# EASTERN CORRIDOR SEGMENTS II AND III (PID 86462) US 50 CORRIDOR FOCUS AREA ADVISORY COMMITTEE MEETING NOTES

## Meeting Dates

Figure I-13E

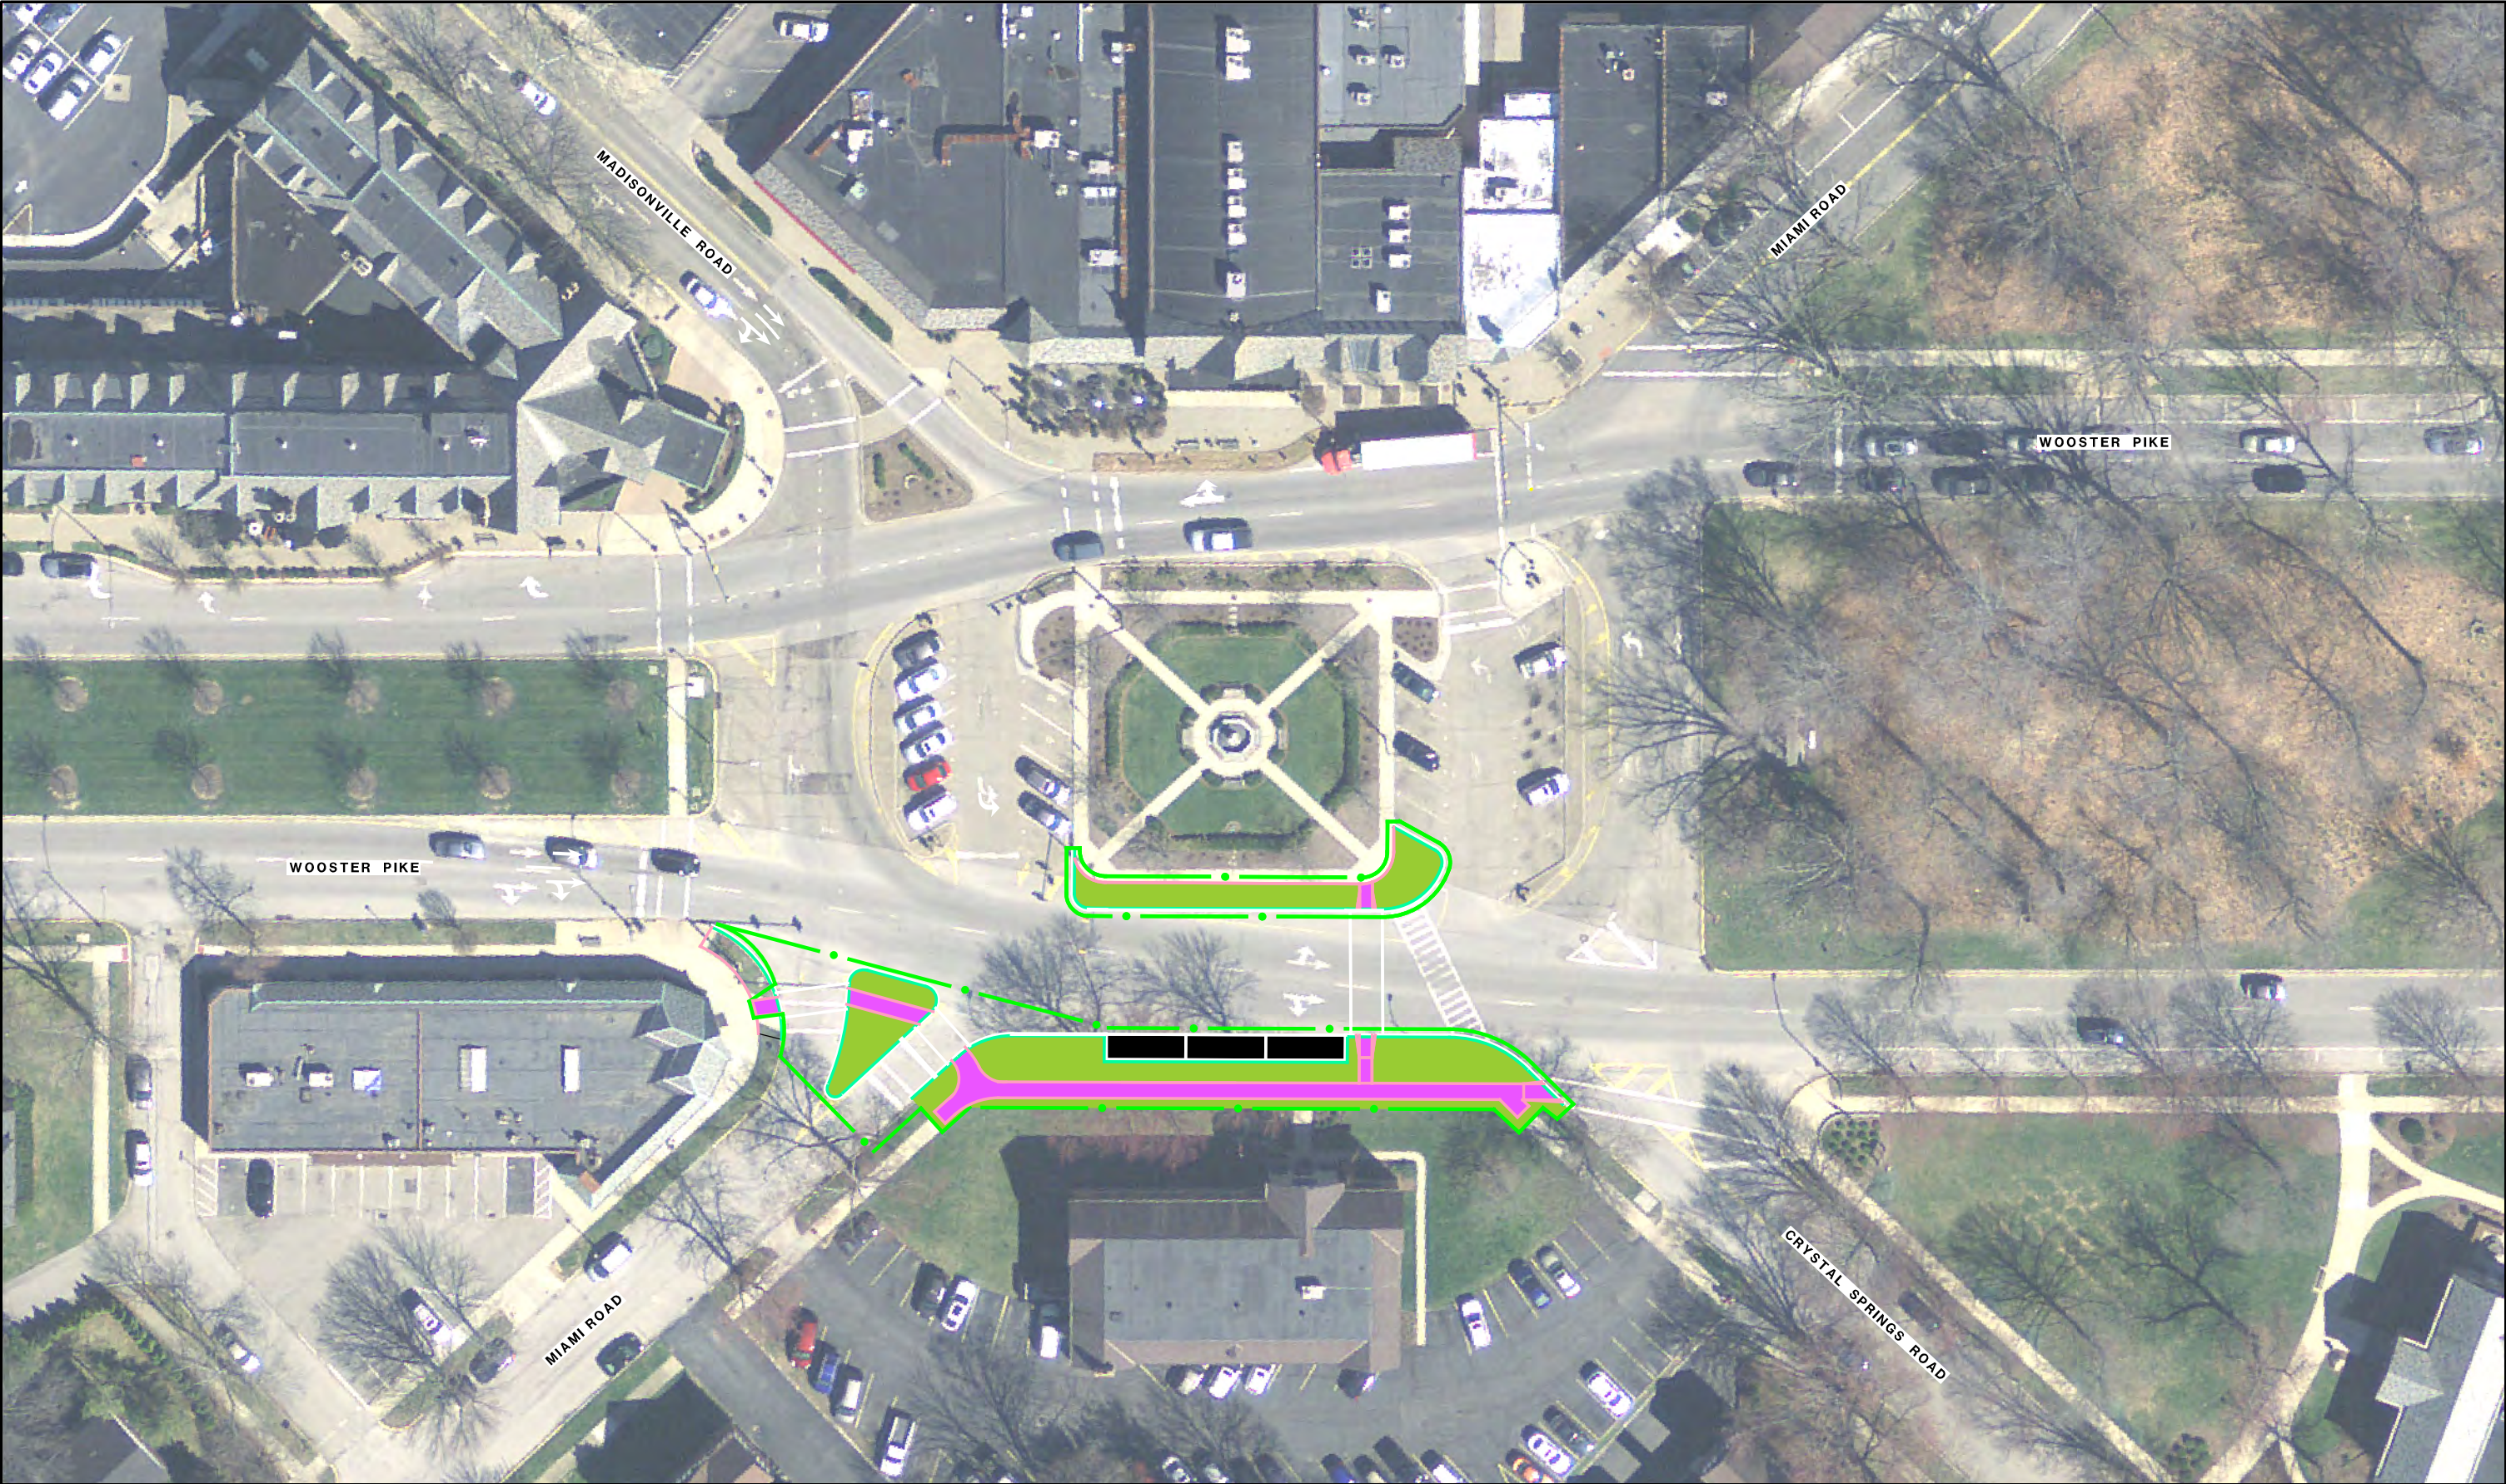
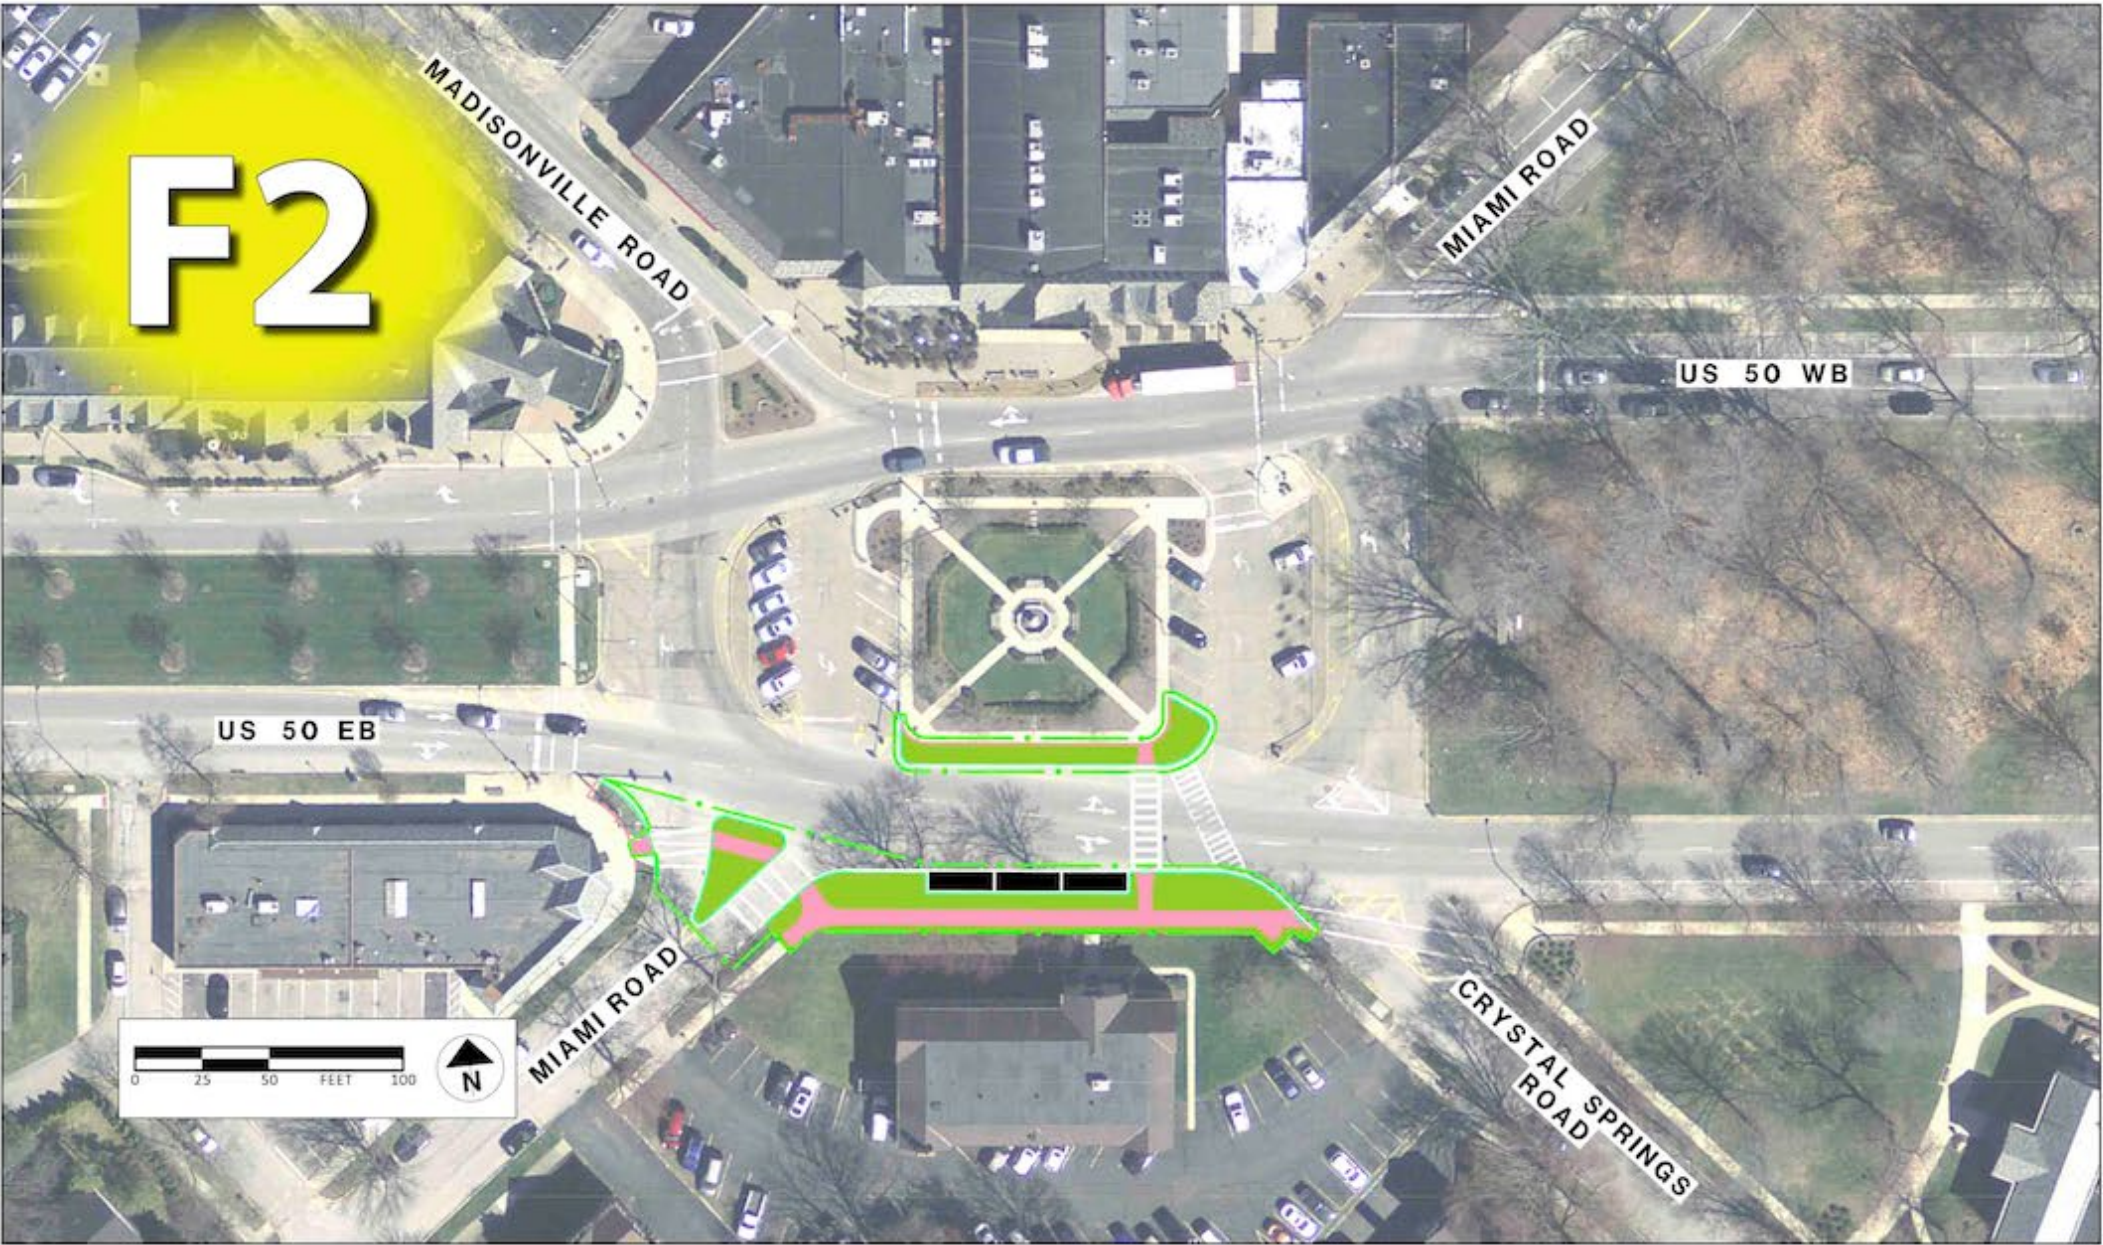
- Mariemont will provide sketch outlining design options. Limited time being allowed to submit comments did not allow Mariemont to submit sketch at this time. Continued dialogue is needed to address safety, parking, and aesthetics.

- Include project in Implementation Plan as a low priority. It will be up to the Village of Mariemont to choose between concepts I-13d (F1) and I-13e (F2) and decide whether or not to implement the project.
- Consider advancing the sidewalk relocation component as a separate, higher priority project.
